**Proposal #07: 5155-04-81**  
**Oregon - Evansville**  
**STH 138 to STH 92**  
**USH 14**  
**Dane County**

**5155-00-79, WISC 2021302**  
**Madison - Evansville**  
**STH 92 Intersection**  
**USH 14**  
**Dane County**

This is Addendum No. 01, which provides for the following:

Addendum No. 01  
 ID 5155-00-79  
 Revised Sheet 16  
 May 4, 2021

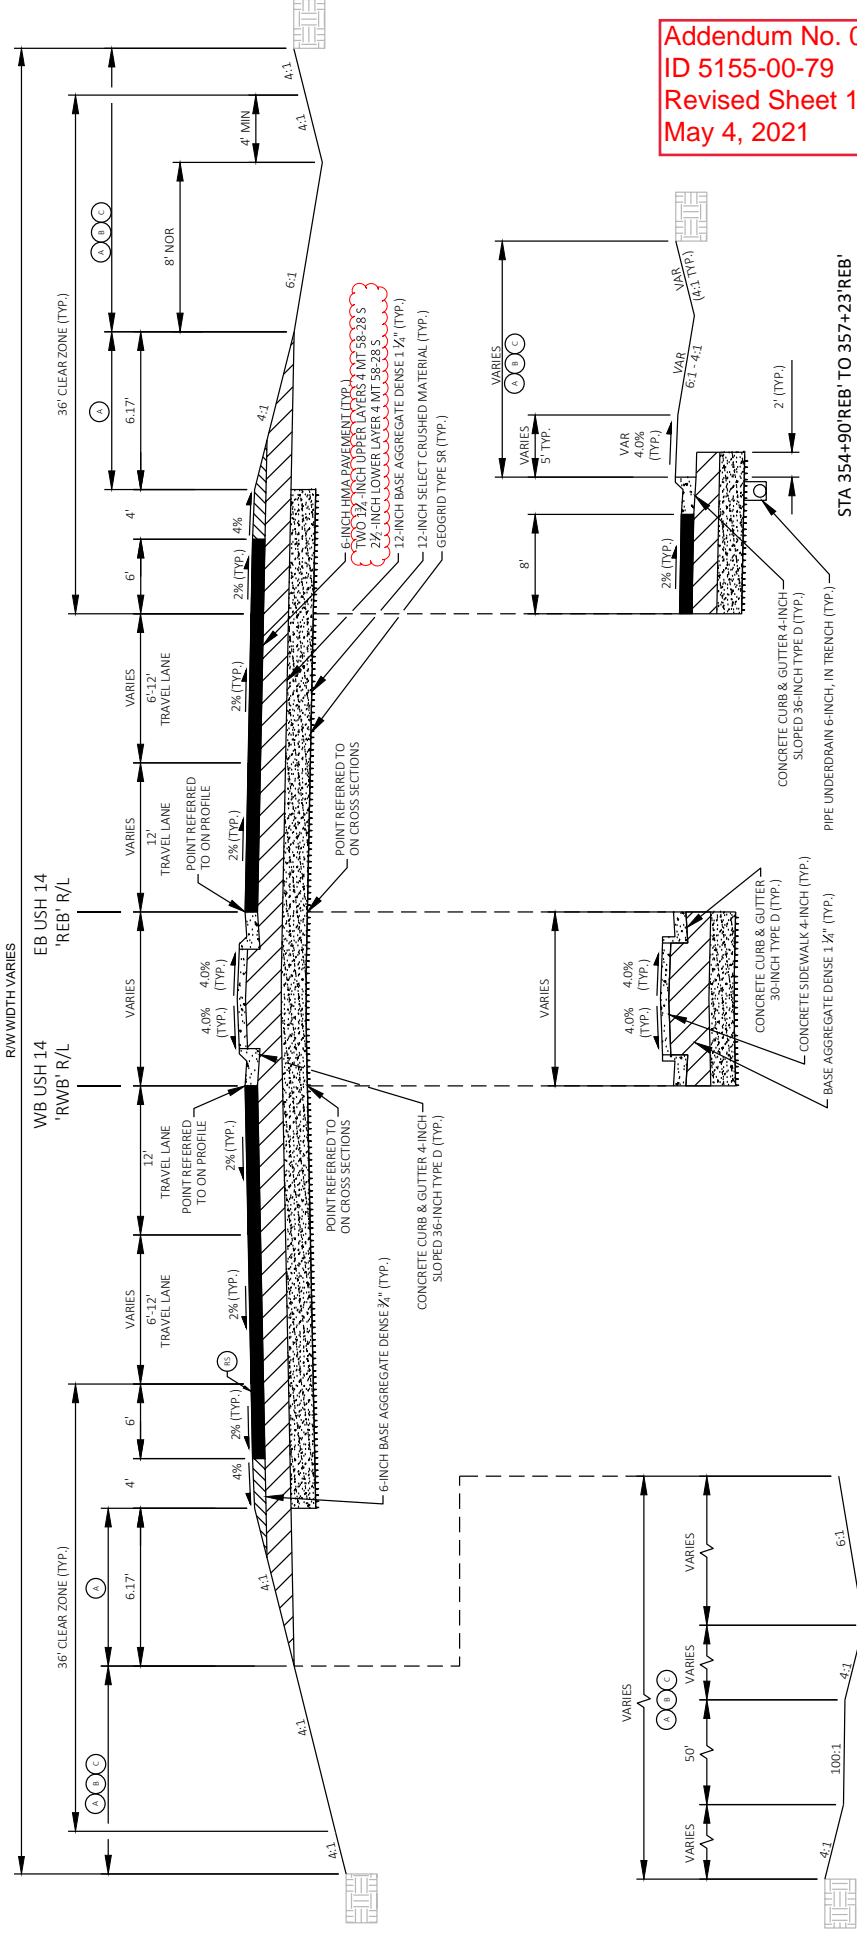
Revised Plan Sheets	
Plan Sheet	Plan Sheet Title (brief description of changes to sheet)
15-16	Finished Typical Sections (asphalt layer thicknesses for USH 14 within the roundabout limits changed to two 1¾-inch upper layers and 2½-inch lower layer)
